SUBJECT: SERVICE UPDATE S0612 SPECTAL WINDOW

LATCH KIT

MODELS AFFECTED: ALL SCHOOL BUSES WITH SPECTAL WINDOWS

Spectal Window Latch Repair Kit

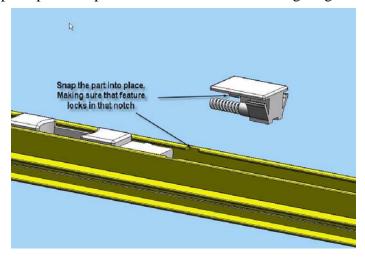
Window latch spring retainer tab breaks.

Install Spectal latch retainer kit on each broken window latch.

- 1. Insert the spring in to the plastic base.
- 2. Snap the part into place as shown on the following diagram.
